AIRPORT LAND USE COMMITTEE (ALUC)

AGENDA

Date: Thursday, January 28, 2016

San Carlos Airport Part 77 Airspace Protection Surfaces

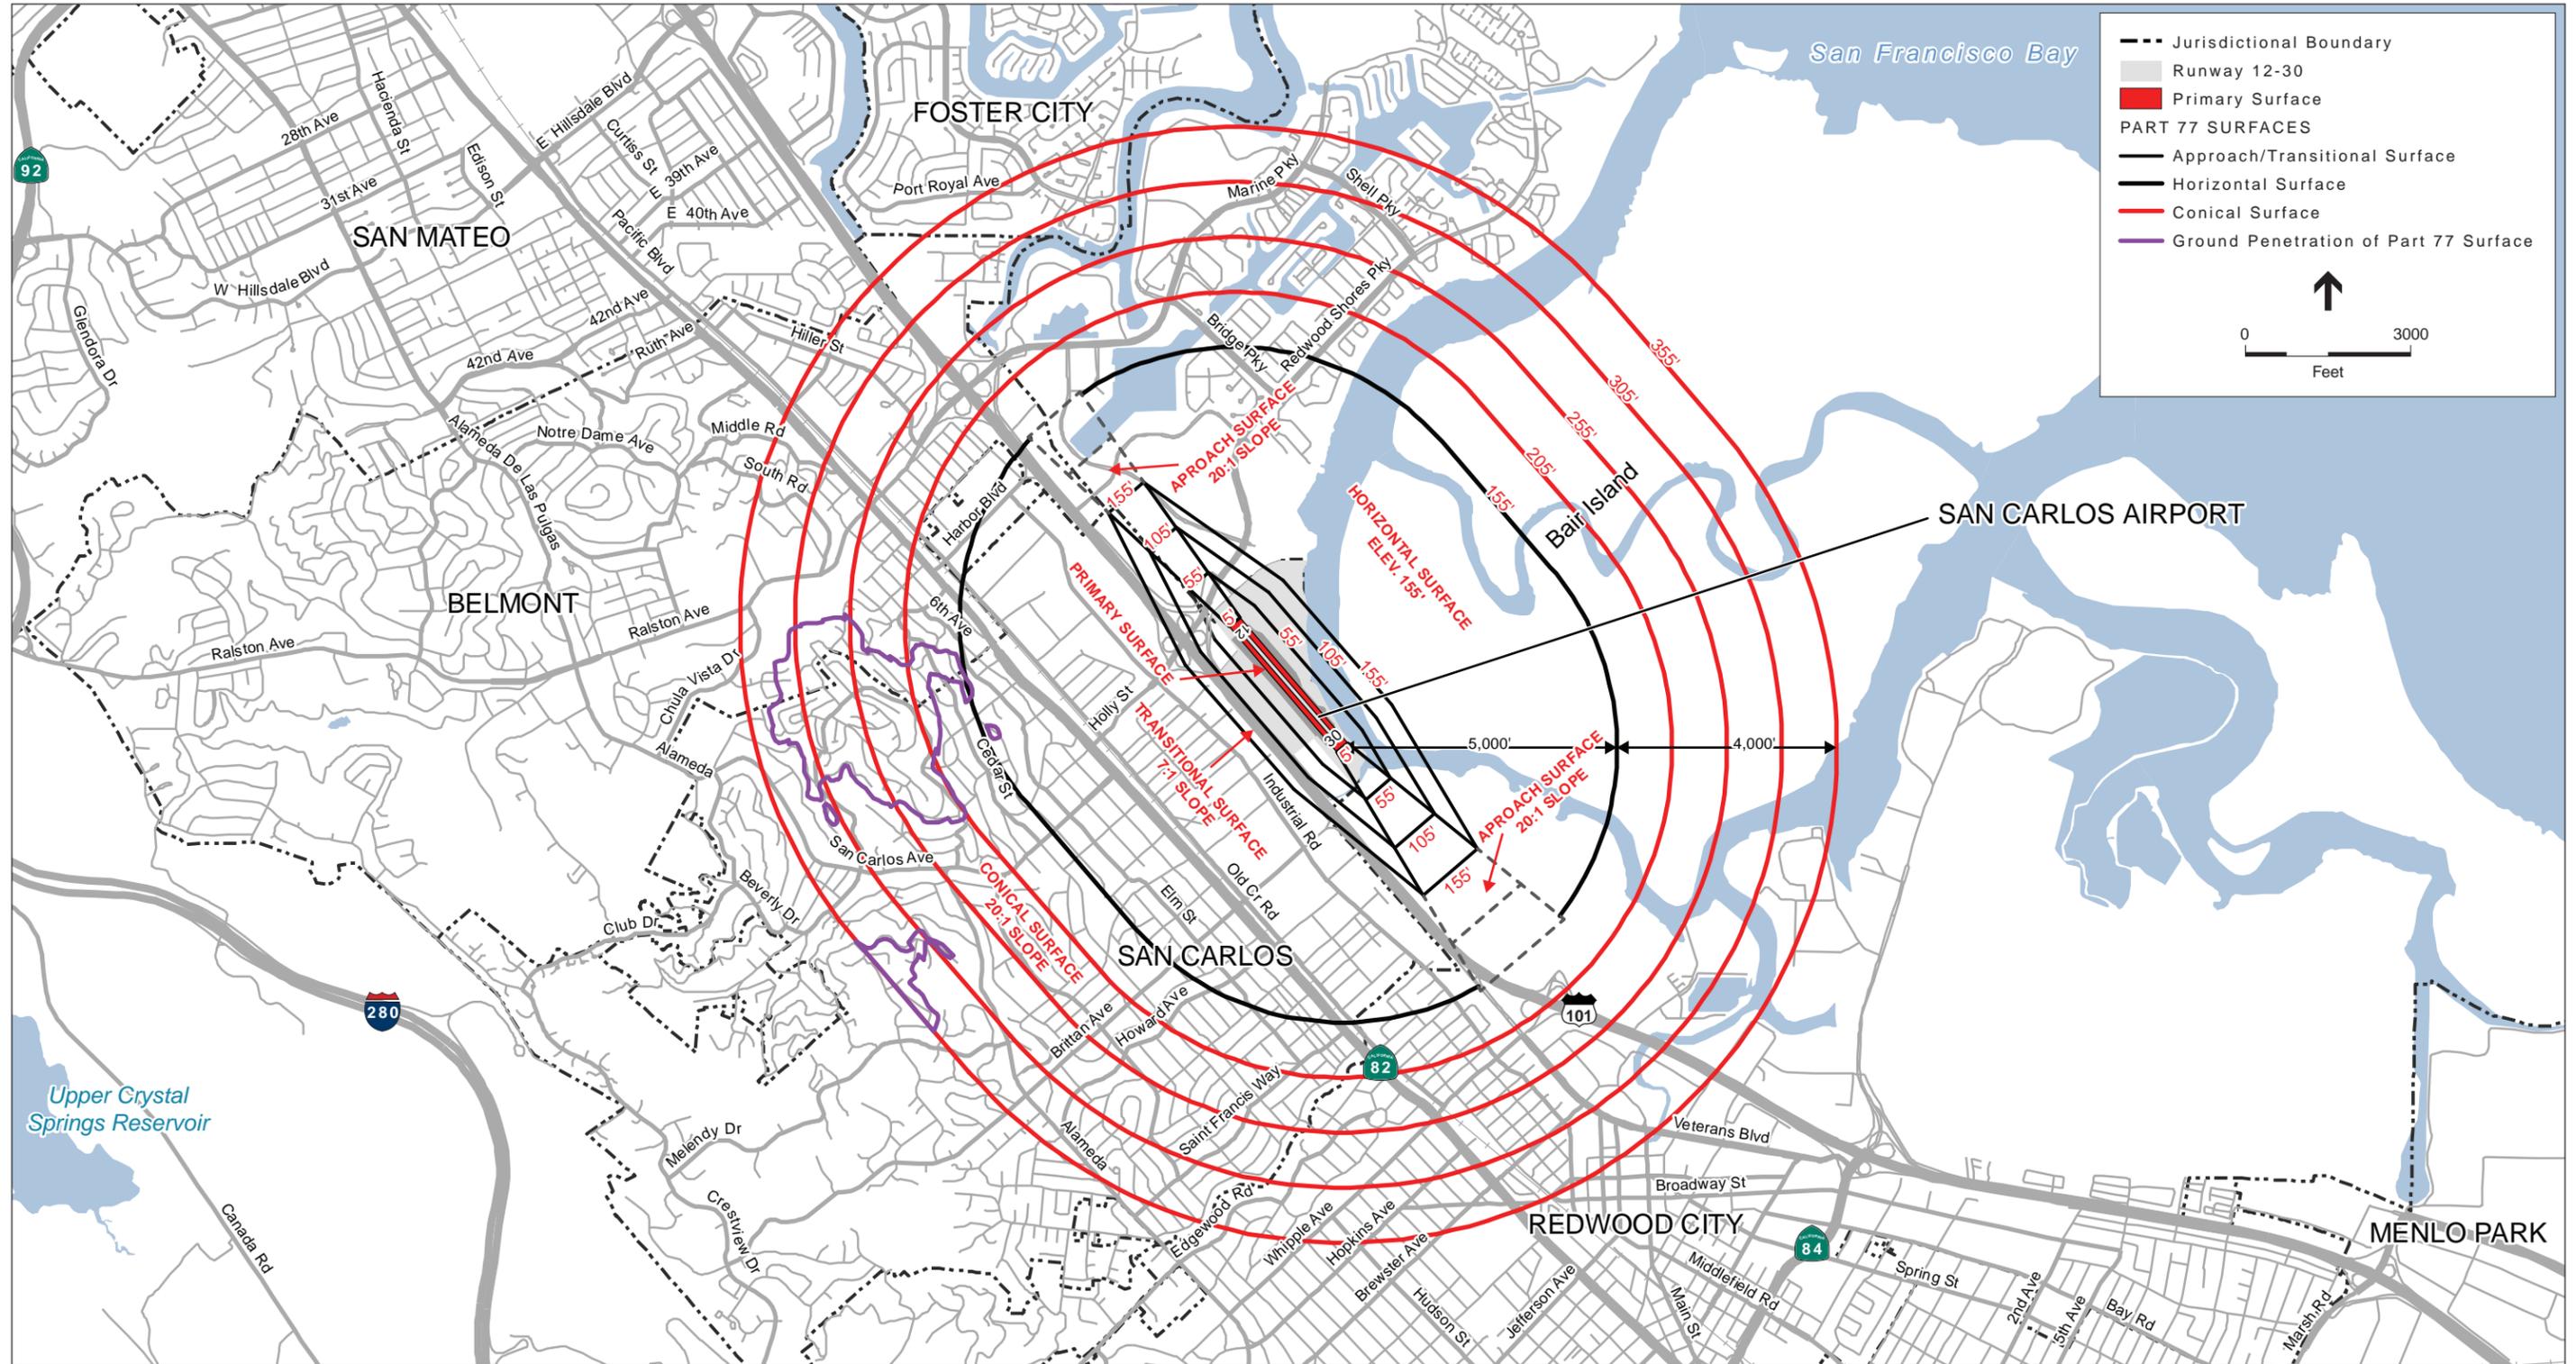
The City of Redwood City is located inside of the 14 CFR Part 77 horizontal and conical imaginary surface contours. The parcel for the Oracle Design Tech High School is located within the conical surface contours. The height for the imaginary surface established for the conical surface is at approximately 255 feet above mean sea level. The project parcel is located at approximately 5 feet above mean sea level. The building will be constructed at a maximum height of 38 feet. Therefore, the Oracle Design Tech High School Project is consistent with the airspace criteria as established in the adopted SQL ALUCP.
